UNITED STATES PATENT AND TRADEMARK OFFICE

APPLICATION NO.	FILING DATE	FIRST NAMED INVENTOR	ATTORNEY DOCKET NO.	CONFIRMATION NO.
09/822,606	04/02/2001	Paul Gaschke		8217

Office Action Summary

DETAILED ACTION

Fig. 1 below).

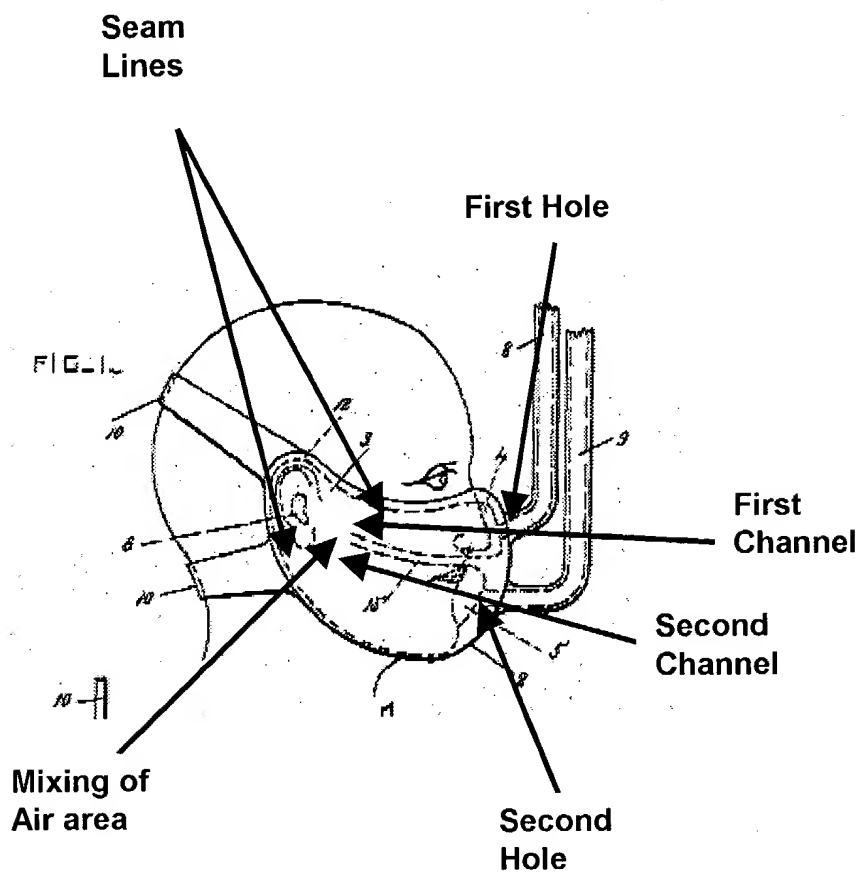
Conkle in a mask discloses:

- a garment (2) adapted and configured to fit over a portion of a user's face;
- a first member (4) defining a first hole (see illustration of Fig. 1 below) in fluid communication with the nostrils of the user and a first channel (see illustration of Fig. 1 below) adapted and configured for accepting air flowing from the first hole, the first channel diverting the air laterally from the nostrils (see illustration of Fig. 1 below; inasmuch as air flows from the nostrils of the user and hits element 15, this thereby causing a lateral diverting of air from the nostrils), said first member being attached to said garment (2, note seam lines illustrated in Fig. 1 below); and

- a second member (5) defining a second hole (see illustration of Fig. 1 below) in fluid communication with the mouth of the user and a second channel (see illustration of Fig. 1 below) adapted and configured for accepting air flowing from the second, said second member being attached to said garment (2, note seam lines in Fig. 1 below);

- wherein a portion of the first channel is received within the second channel, and the air from the nostrils mixes with the air from the mouth in the second channel (see illustration of Fig. 1 below; inasmuch as air flows from the nostrils and mouth when the user breaths, this creates a flow of air from the

nostrils and mouth which would meet in the area depicted below illustrated in

With respect to claim 28, Conkle discloses wherein the second channel is adapted and configured to divert the air laterally from the mouth (inasmuch as air leaves the mouth of the user and hits element 15 this creates a diverting of air laterally from the mouth) and said second member (5) defines at least one exhaust port (via 9) for exhausting the nostril air and mouth air to ambient.

With respect to claim 30, Conkle discloses wherein said first member (4) includes a barrier (15) adapted and configured to direct air exhausted from one nostril to flow within the first channel (see illustration of Fig. 1 above) in front of the other nostril (inasmuch as when the user breaths out air via a nostril the air hits element 15 and therefore would divert flow within the first channel in front of the other nostril, by the movement of the air out of one nostril hitting element 15 some of the air would flow in front of the other nostril).

With respect to claim 31, Conkle discloses a garment (2) adapted and configured to fit over a portion of a user's face (Fig. 1); a first member defining a first hole (see illustration of Fig. 1 above) in fluid communication with the nostrils of the user and a first channel (see illustration of Fig. 1 above) adapted and configured for accepting air flowing from the first hole, the first channel diverting the air laterally from the nostrils (see illustration of Fig. 1 above), said first member including a barrier (15) adapted and configured to direct air exhausted from one nostril to flow within the first channel (see illustration of Fig. 1 above) in front of the other nostril (inasmuch as when the user breaths out air via a nostril the air hits element 15 and therefore would divert flow within the first channel in front of the other nostril, by the movement of the air out of one nostril

hitting element 15 some of the air would flow in front of the other nostril), said first member being attached to said garment (see seam lines depicted above with respect to illustration of Fig. 1); and a second member (see illustration of Fig. 1 above) defining a second hole (see illustration of Fig. 1 above) in fluid communication with the mouth of the user and a second channel (see illustration of Fig. 1 above) adapted and configured for accepting air flowing from the second hole, said second member being attached to said garment (see seam lines depicted above with respect to Fig. 1).
